SUBJECT: ISSUANCE OF AMENDMENT TO FACILITY OPERATING LICENSE NO. DPR-18

R. E. GINNA NUCLEAR POWER PLANT

Amendment No. 25
License No. DPR-18

SAFETY EVALUATION BY THE OFFICE OF NUCLEAR REACTOR REGULATION
RELATING TO STEAM GENERATOR TUBE PLUGGING AT 15 PERCENT LEVEL
SUPPORTING AMENDMENT NO.25 TO FACILITY OPERATING LICENSE NO. DPR-18
ROCHESTER GAS AND ELECTRIC CORPORATION
R. E. GINNA NUCLEAR POWER PLANT
DOCKET NO. 50-244

FIGURE 2.1-1
CORE DNB SAFETY LIMITS
2 LOOP OPERATION

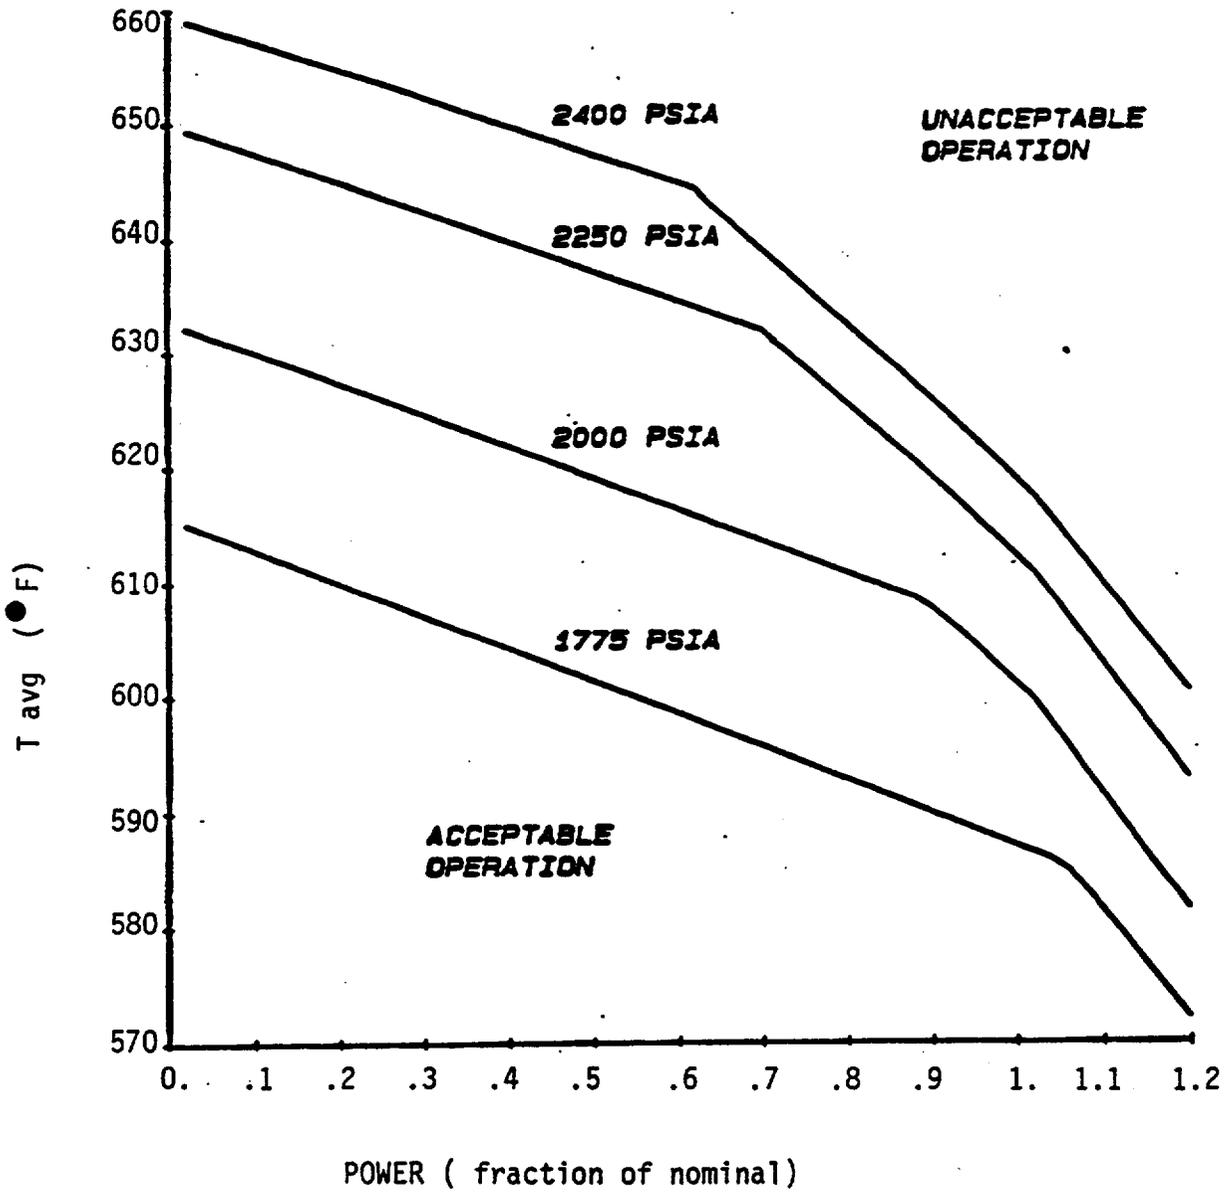
The Technical Specifications changes submitted in Reference 1 for review and approval include: (1) changes in DNBR safety limits (Figure 2.1-1) reflecting the reduced RCS flow resulting from higher percentage of the plugged steam generator tubes, (2) changes in setpoints for Overtemperature and Overpower Delta-T trips (pages 2.3-2 and 2.3-3 of the Technical Specifications) reflecting the changed DNBR safety limits discussed in item (1) above, and (3) changes to bases (pages 2.3-6 to 2.3-9 of the Technical Specifications) to include updated descriptions and references.

The staff has reviewed the proposed Technical Specifications changes and found that the changes are acceptable since the changes discussed in items (1) and (2) are consistent with the assumptions used in revised safety analyses which demonstrate that the appropriate acceptance criteria are satisfied, and changes discussed in item (3) are editorial changes (Reference 3) and have no safety significance.
